PROCLAMATION CALLING A SPECIAL MEETING OF THE BERKELEY CITY COUNCIL

Thursday, July 23, 2020

2 OPTION 2 - PROPOSED EAST ELEVATION
 Scale: N.T.S. / Based on Eisenman Architecture drawing 4/A3.1 dated 06.27.19

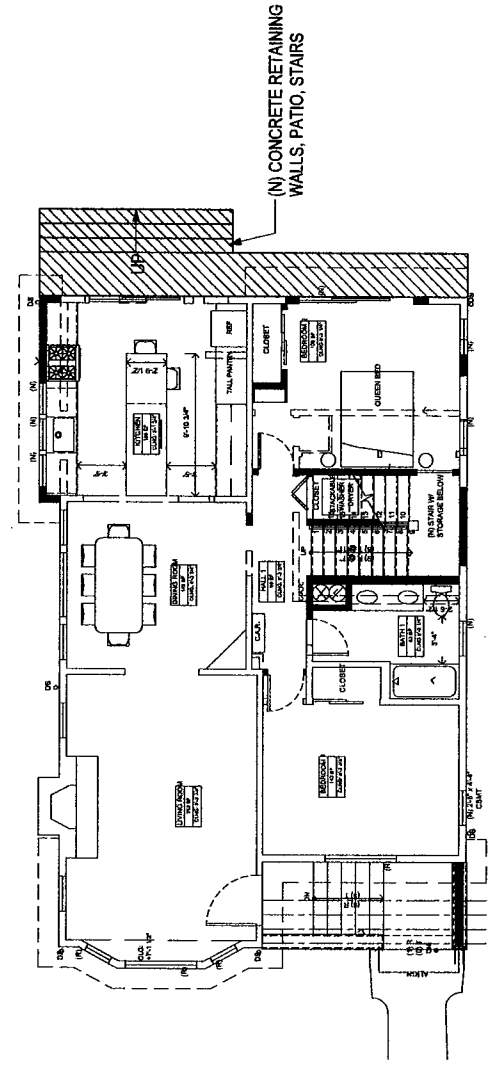
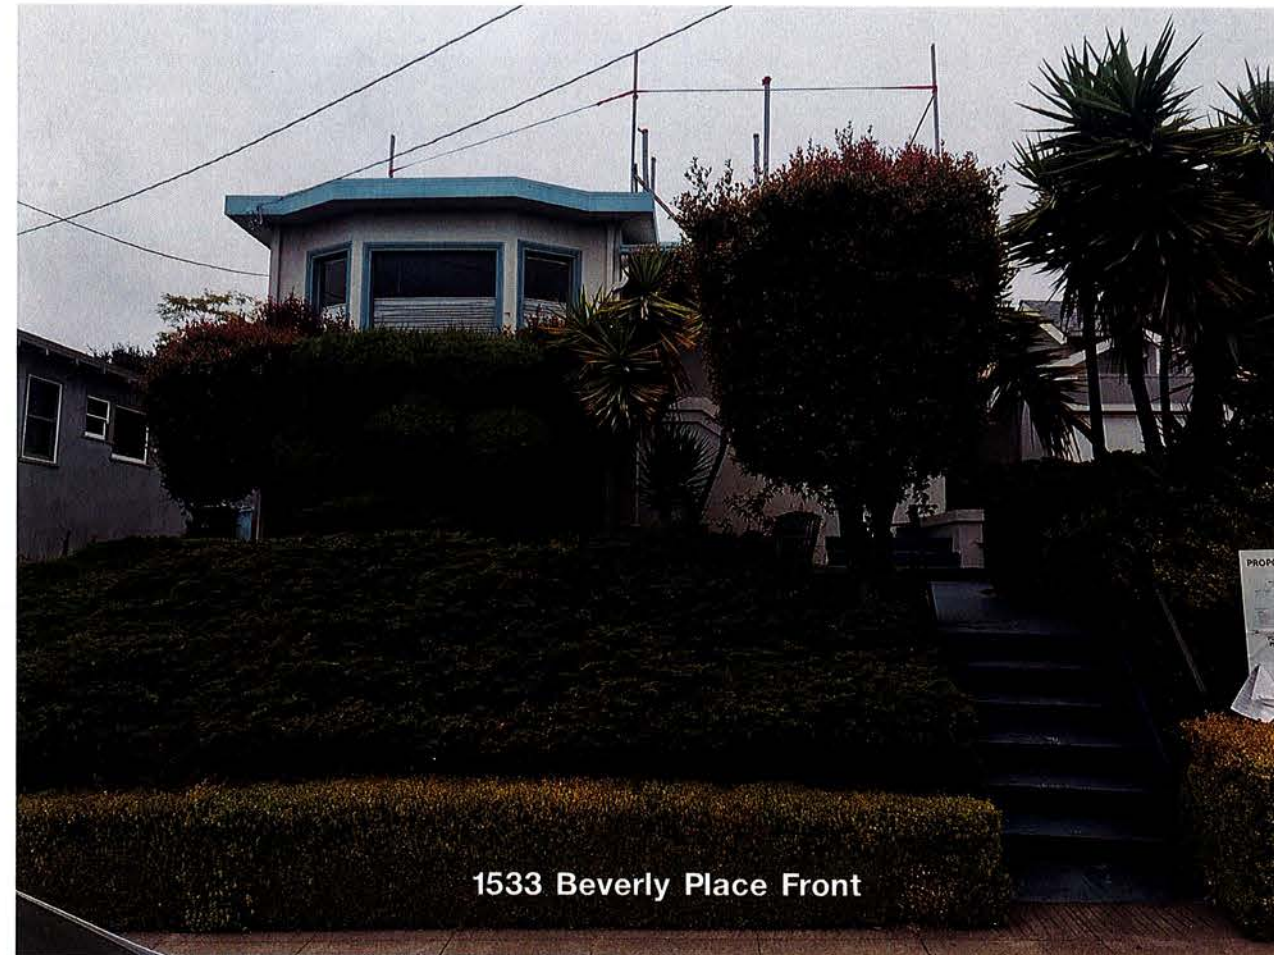
TAB 8 Appellant's Architect Suggestion and Rationale: Option 2: Everything lowered 24"

The Applicants' Architect claims that lowering the building any further is not feasible due to cost and the need for emergency egress.

Since the design already includes lowering the building and because the entire foundation will be replaced anyway this solution is viable as it would add only a small percentage to the total project cost (estimate \$20,000 to \$30,000) to cover the additional 60 to 70 cubic yards of earth to remove and the construction of 2' high retaining walls. Design and construction detailing options are many and can be handled as a matter of course.
